Access Compliance Report Public Rights-of-Way (Curb Ramps)

Main Street: ROSSMOOR_CENTER_WAY Cross Street: N/A Location: SW

ADA ID: RPRK211208115931 Ramp Type: Type 1 - Perpendicular Initial Pass/Fail: Fail Overall Compliance: No Severity Score: 2

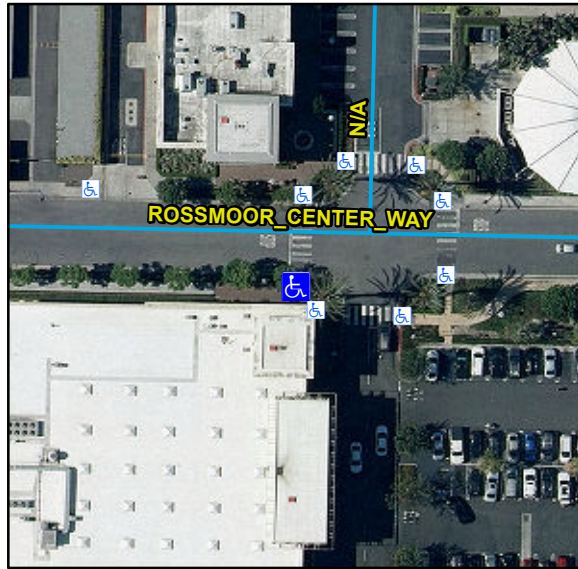
R304.2.2, R304.5.3, STD 1115

Remove & Replace Entire Ramp.
